**SA-17-037 CAMPAIGN AA860 CONNECTING
ROD UPDATE**

**GROUP: 0-GENERAL
BULLETIN NO: SA-17-037
DATE: 4-3-2018**

Release Date:	April 3, 2018
Affected Years:	Certain 2011-2012 MY Conventional Trucks
Affected Models:	Certain Conventional Trucks Equipped with a J08 Engine
Attention:	Service Managers / Service Personnel / Technical Service Managers

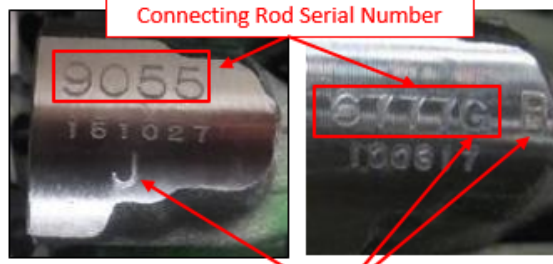
3. Record the serial number and date code that appears on the connecting rod cap.

- If only numeric characters are present, check the date code. If the date code is 101227 or later, engine repair is not required. If the date code is 101226 or earlier, engine repair is required. (See photo below at left).
- If any alphabetical characters are present in the serial number, engine repair is not required. (See photos below at right).

If only numeric characters present, check the date code on the connecting rod:

- 101227 (December 27th, 2010) or later, NO ENGINE REPAIRS ARE REQUIRED.
- 101226 (December 26th, 2010) or earlier, ENGINE REPAIR IS REQUIRED.

If alphabetic characters are present on the connecting rod, NO ENGINE REPAIRS ARE REQUIRED.
